# Power Supply Ripple and MDI Return Loss Modifications

GITESH BHAGWAT

ANALOG DEVICES

# Low Frequency MDI Return Loss and Transmitter Droop

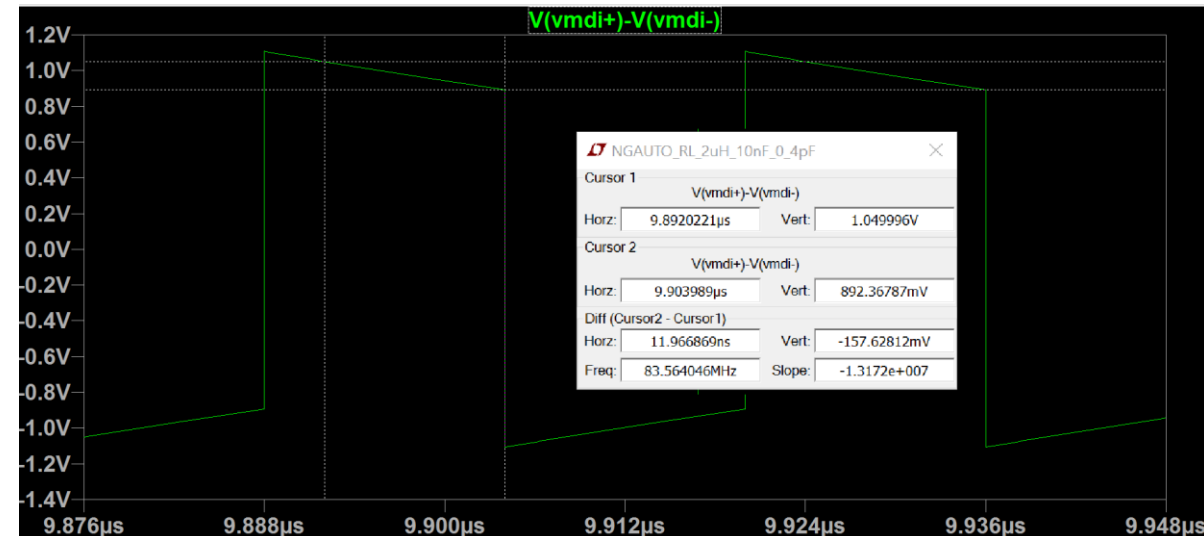
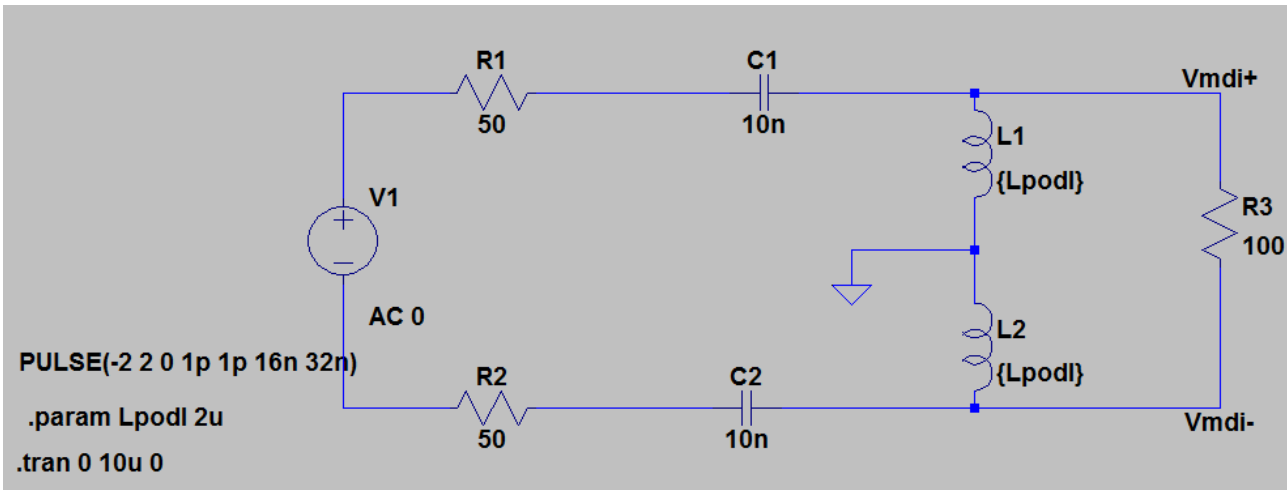
- ▶ Coupling circuit for droop simulation:
  - 2uH coupling inductor
  - 10nF coupling capacitor
- ▶ Droop calculated = 15%
  - $\text{Droop} = \frac{(1.0499 - 0.89236)V}{1.0499V} \times 100$  in 12ns
- ▶ Verify insertion loss HPF pole at 1.85Mhz
- ▶ Measure low frequency return loss for these values

# Low Frequency MDI Return Loss and Transmitter Droop

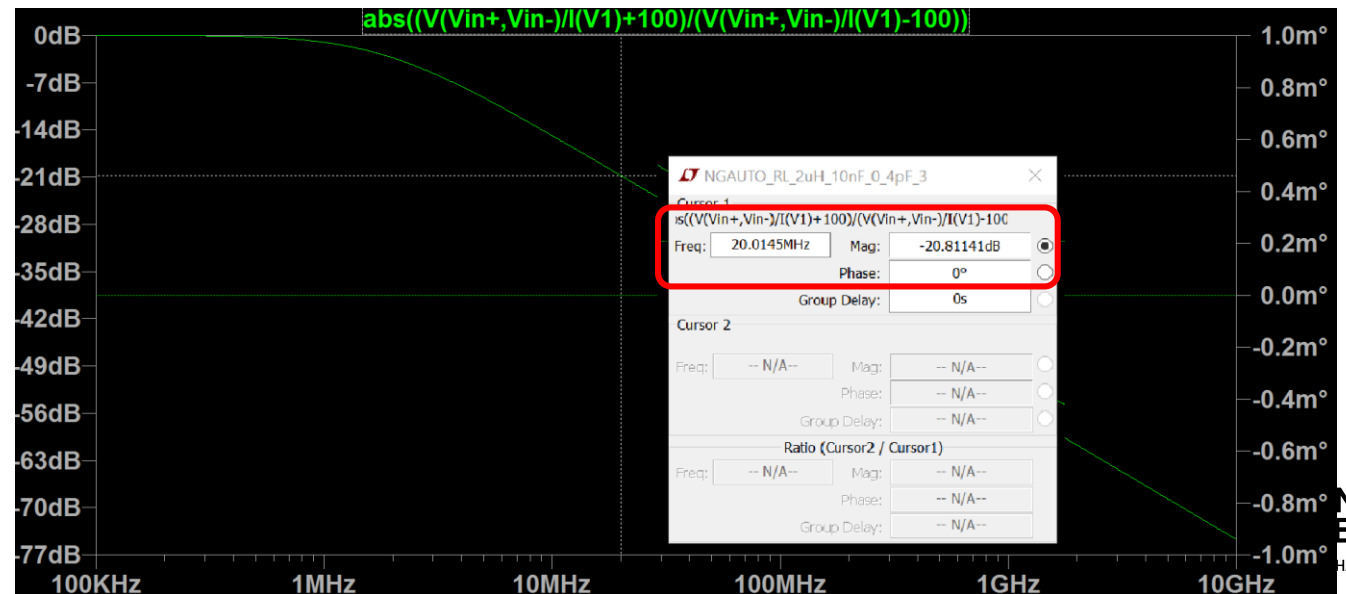
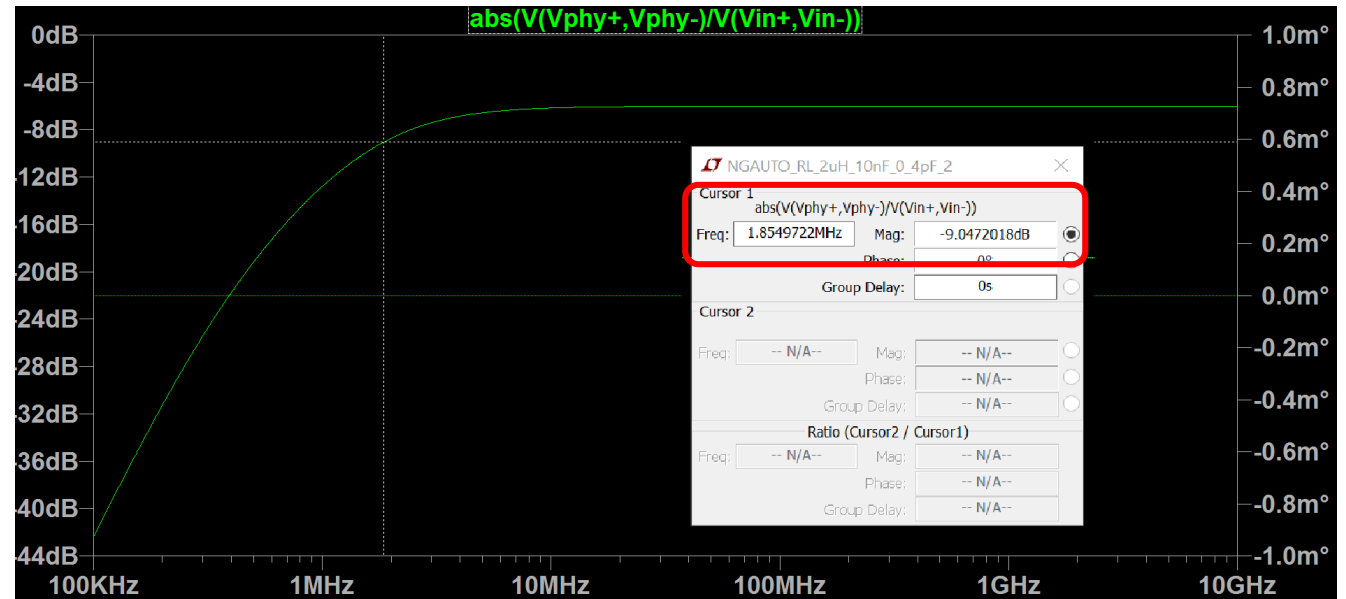
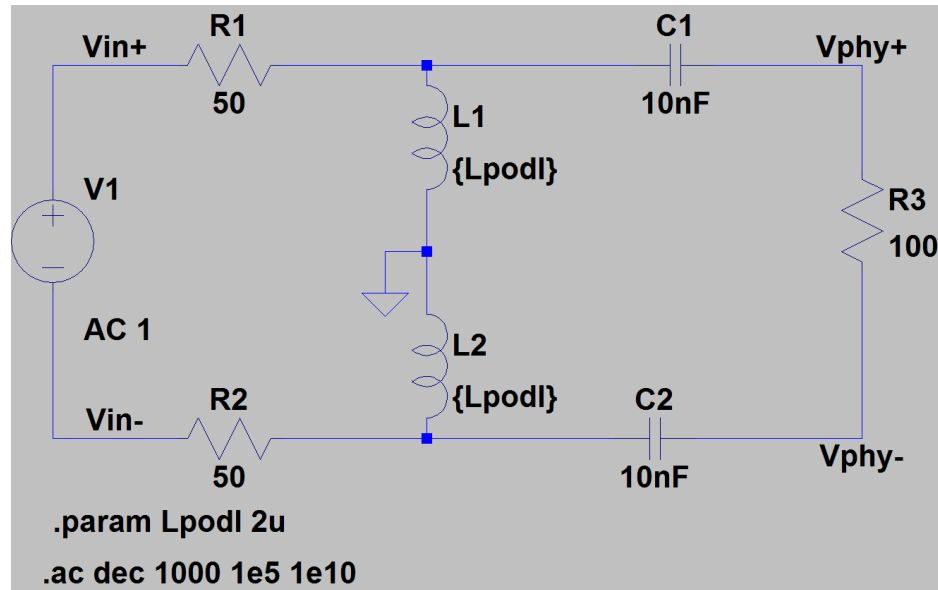
- ▶ HPF pole in insertion loss at 1.85 MHz verified
- ▶ Return Loss has a breakpoint of
  - -20dB at 20MHz
- ▶ Change the low frequency MDI return loss breakpoint to align with this

- ▶ Change the edit to clause 149.8.2.1 MDI return loss to change the low frequency breakpoint

- **$20 - 20 \times \text{Log}_{10}\left(\frac{20}{f}\right)$**      **for  $2 \leq f \leq 20$**
- **20**     **for  $20 \leq f \leq 500$**
- $12 - 10 \times \text{Log}_{10}\left(\frac{f}{3000}\right)$      for  $500 \leq f \leq 3000$
- $12 - 20 \times \text{Log}_{10}\left(\frac{f}{3000}\right)$      for  $3000 \leq f \leq 4000$

MDI Return Loss Masks- Comparison

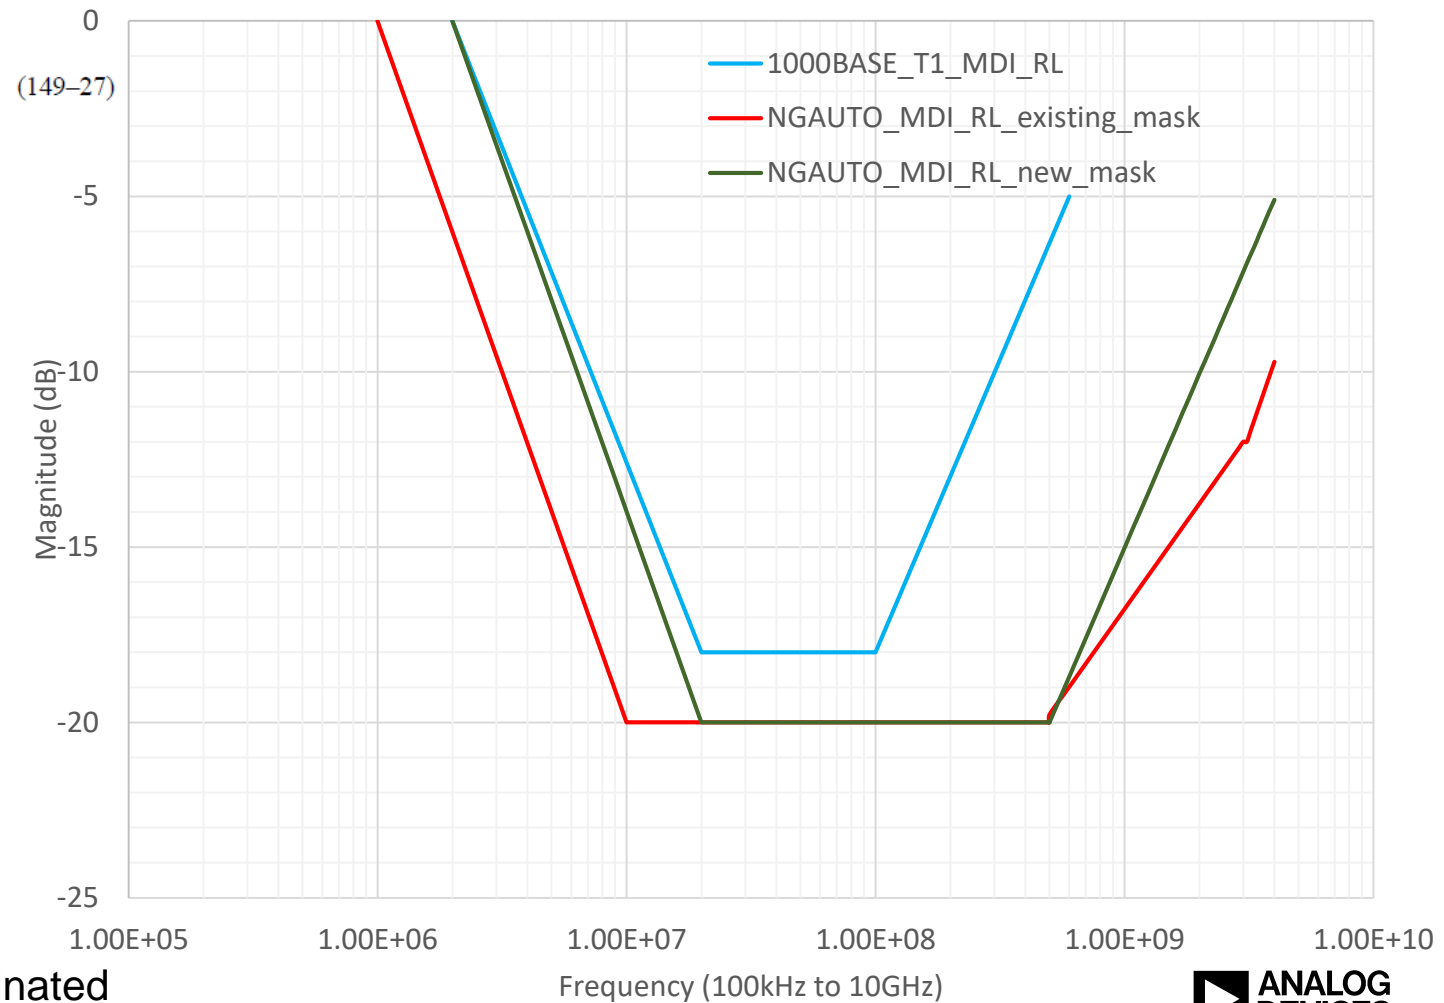
► Note: discontinuity in previous mask has been eliminated

- $20 - 20 \times \text{Log}_{10}\left(\frac{20}{f}\right)$  for  $2 \leq f \leq 20$
- $20$  for  $20 \leq f \leq 500$
- $20 - 16.5 \times \text{Log}_{10}\left(\frac{f}{500}\right)$  for  $500 \leq f \leq 4000$

MDI Return Loss Masks

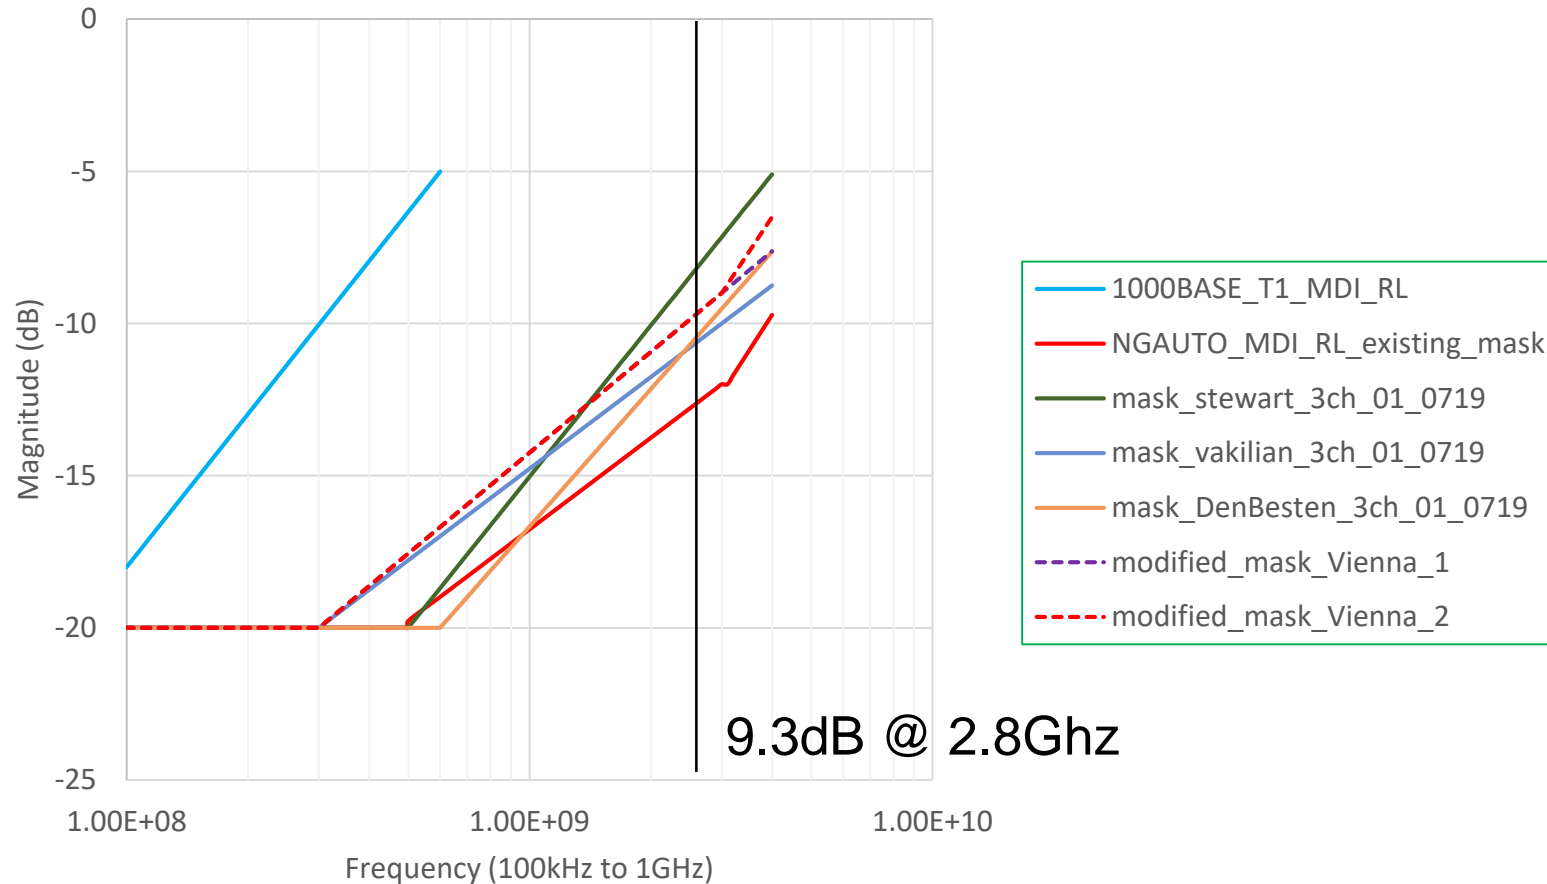
- ▶ Using masks from [vakilian\\_3ch\\_01\\_0719.pdf](#) and [DenBesten\\_3ch\\_01\\_0719.pdf](#)

- $20 - 20 \times \text{Log}_{10}\left(\frac{10}{f}\right)$  for  $1 \leq f \leq 10$
- 20 for  $10 \leq f \leq 300$
- $20 - 11 \times \text{Log}_{10}\left(\frac{f}{300}\right)$  for  $300 \leq f \leq 4000$

- $20 - 20 \times \text{Log}_{10}\left(\frac{10}{f}\right)$  for  $1 \leq f \leq 10$
- 20 for  $10 \leq f \leq 300$
- $20 - 11 \times \text{Log}_{10}\left(\frac{f}{300}\right)$  for  $300 \leq f \leq 3000$
- $9 - 20 \times \text{Log}_{10}\left(\frac{f}{3000}\right)$  for  $3000 \leq f \leq 4000$
